DRAWING TITLE
BLDG 2 THIRD FLOOR PLAN - AREA G2

PROJECT TITLE
SLVHCS REPLACEMENT MEDICAL CENTER PROJECT

DOCUMENT SET PACKAGE
WP_08

2AI103-G2

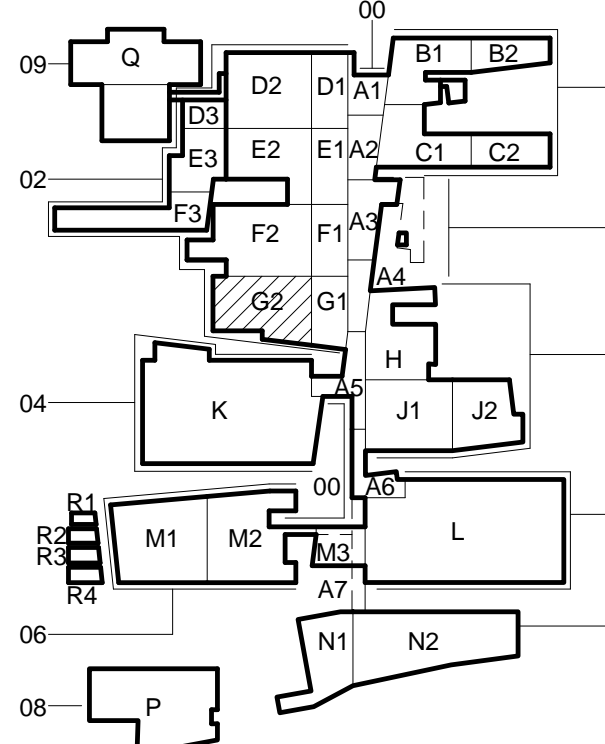
All noted PD's & CR's on this page were either added, removed, clarified or relocated per RFI 04695

REFER TO SKETCH: SK-8-1-NJ-2-AI-103-G2-1

RFI 06254: Female Staff Lockers

RFI 02082: A 6AC

See CO-05Q

RFI 04422: Marker board 6'-4" from West wall to C/L

RFI 03037: Fire retardant casework required.

SEE RFI 05314: Shifts wall and sink 20" North to accommodate foot pedals and bedpan washer

RFI 0584: Shaft wall to be coordinated to fit duct risers

SEE RFI 02746 - EXPAND COLUMN WRAP 3" EAST TO ACCOMMODATE 6" GW RISER

REFER TO THE FOLLOWING SKETCH FOR CHANGES: SK-8-4-NJ 2AI003
